SB-10058549-9447

TO: Mercedes-Benz Dealer Principals, General Managers, Sales Managers, Service Managers, Parts Managers	FROM: Thomas Brunner, Department Manager, Vehicle Compliance and Analysis, Engineering Services
RE: Service Campaign 2015050002 –Retrofit Headlamp Adjustment Screw Caps. Model 205 (C-Class Sedan) Model Year 2015	DATE: June 12, 2015

Campaign No. 2015050002, June 2015

SUBJECT: **Model 205 (C-Class), Model Year 2015**
Retrofit Headlamp Adjustment Screw Caps

Figure 1

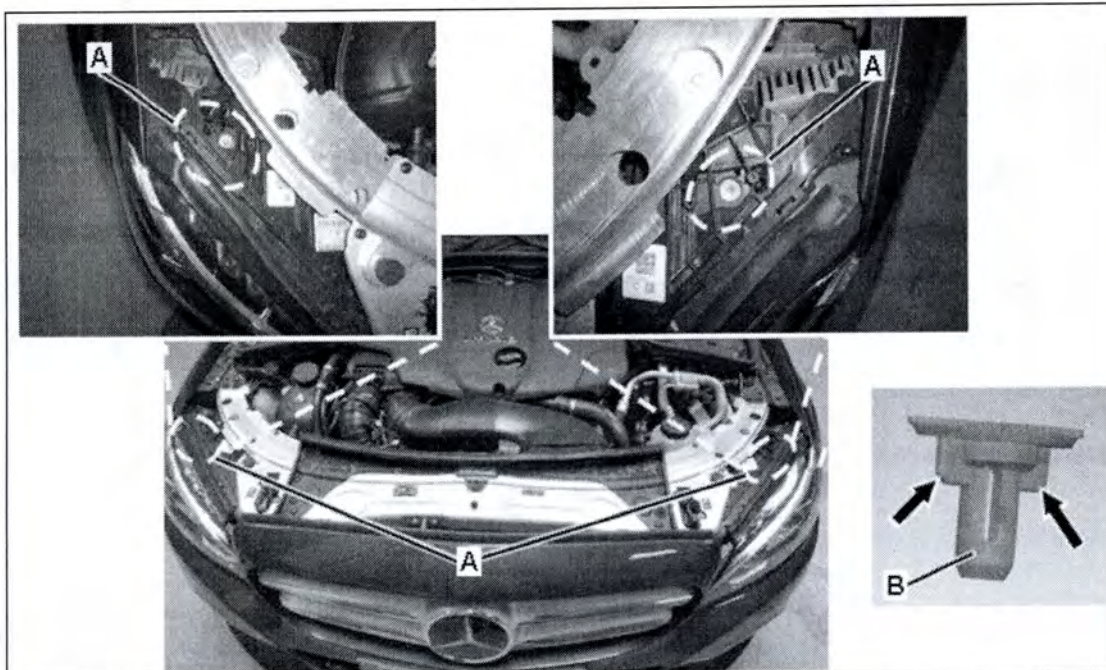
Daimler AG (DAG), the manufacturer of Mercedes-Benz vehicles, has determined that the headlamp horizontal adjustment sealing caps may not have been installed. To correct this condition an authorized Mercedes-Benz dealer will install the headlamp horizontal adjustment sealing caps at the next dealer visit.

1. Open hood.
2. Retrofit cap (B, Figure 1) for headlamp adjustment screws (A) at left and right:
 - Position cap (B, Figure 1) on headlamp adjuster (A) so that the tabs (arrows) on the cap (B) align with the grooves in the adjuster (A).
 - Press the cap (B) into adjuster (A) by hand until it locks into position.

An audible click will be heard when the cap (B) is properly seated into the adjuster (A).
